Consultation summary report – Update to the ISP Methodology

Consultation summary report

For the Integrated System Plan (ISP) for the
National Electricity Market

Figure 4 Possible impact of actionable window on EISD for a project that was actioned in the 2022 ISP and reassessed in the 2024 ISP

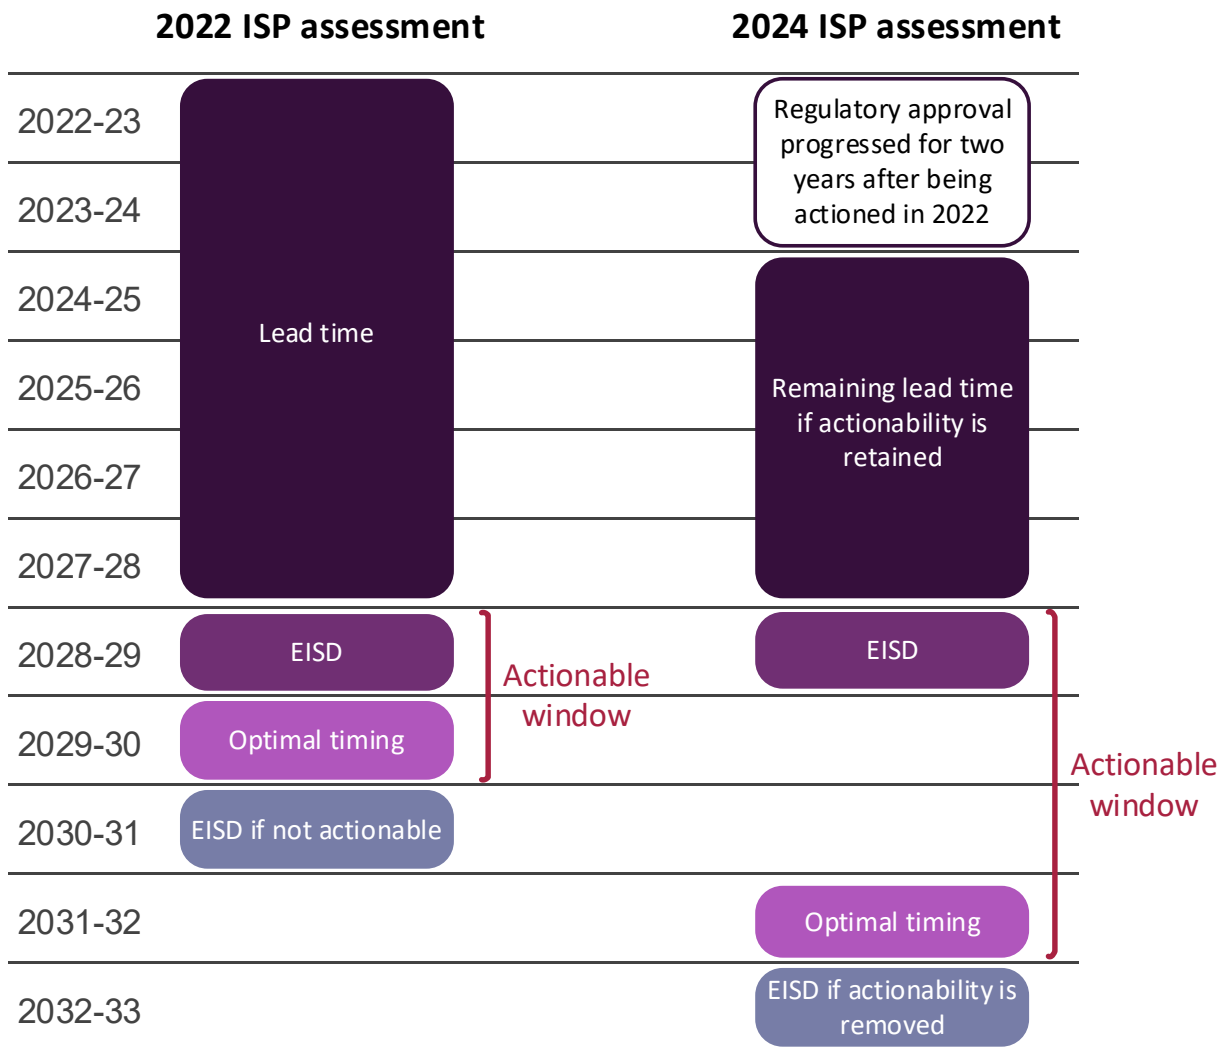
Based on stakeholder feedback, AEMO has revised its position on the actionable window concept. AEMO now considers that an actionable window should be introduced into the ISP Methodology, to further ensure that transmission project lead time uncertainty can be appropriately accommodated through the ISP. Under this new consideration, an actionable window:

- Will allow the cost benefit analysis to reflect a reality that transmission projects on their critical path cannot be paused after two or more years of progress and subsequently resumed without affecting lead time (for example, due to restarting regulatory approvals, planning approvals and community engagement).

- Will not require pre-emptive or unwarranted adjustment of an EISD based on uncertain project delay factors, but will allow consideration of delaying a project (for example, by interrupting regulatory approvals, planning approvals and community engagement) to be appropriately incorporated in the decision about whether a project is determined as actionable.

- Will apply for projects that have previously been assessed as actionable, in one or more previous ISPs, but not for projects that have not previously been assessed as actionable. This reflects the fact that if a project is identified as actionable then a regulatory process is begun, including planning approvals, community engagement and more, and that a change to actionable status would likely mean repeating this work if the project is required at a later date.

AEMO has decided to proceed with amending the ISP Methodology to introduce an actionable window. AEMO considers that the actionable window approach will more accurately reflect the lead time of projects that were actionable in the previous ISP. Projects that were not previously actionable are not affected by this change.

Figure 5 Treatment of losses in the regional and sub-regional models

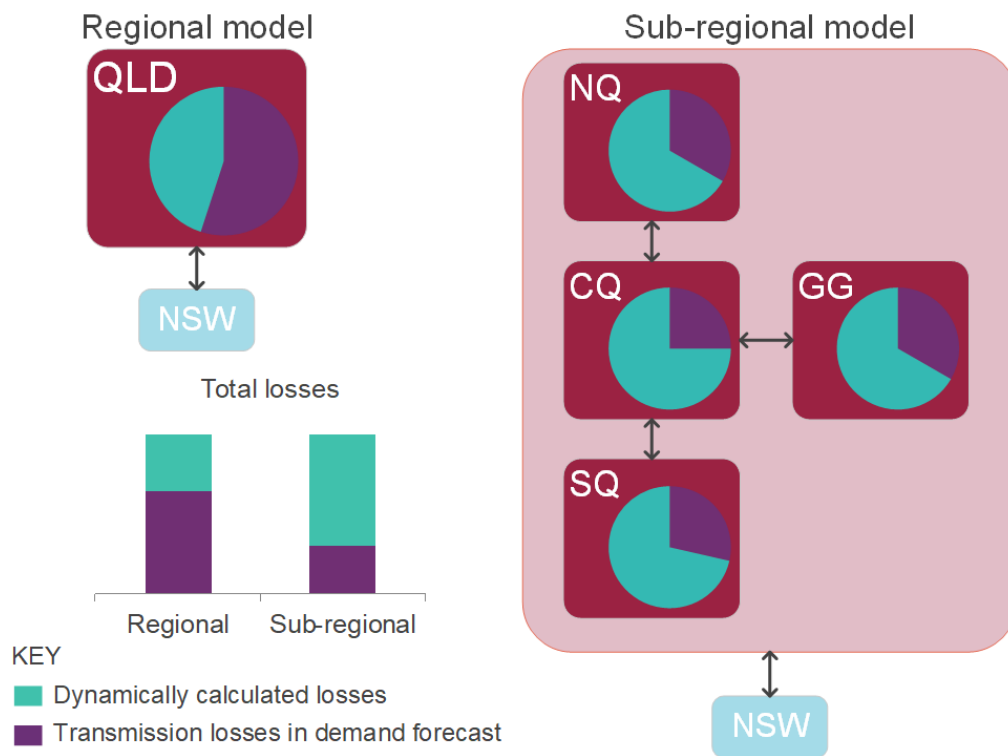
AEMO does not agree with **CEIG** and **Windlab** that static average loss factors should be used for modelling settlement prices and dispatch for generators and loads instead of MLFs. AEMO considers that MLFs should be used for assessing merit order and pricing for generators and loads, consistent with the design of the NEM. Using existing generator MLFs, as opposed to new generator MLFs relative to the sub-region reference nodes, will better reflect the actual dispatch merit order seen in the regional dispatch model currently used in the NEM. AEMO is not proposing to change the treatment of these factors for generators and loads in the ISP so as to stay consistent with the NEM pricing methodology applied in the dispatch process.

In relation to concerns that the additional inter-regional losses being calculated would apply a double penalty to existing generation if the regional generator MLFs are still utilised, it should be noted the purpose of modelling the generator MLFs is not to account for losses but to represent the marginal impact of losses on pricing. The accounting of losses occurs in the loss equations for the flow paths and in the sub-regional demand forecast.

AEMO agrees with **QCC** in relation to being cognisant of development of local demand such as Renewable Energy Industrial Precincts, particularly in the *Green Energy Export* scenario. The inclusion of these demands into sub-regional demand forecasts, where possible, will support more accurate modelling of inter- and intra-regional flows.
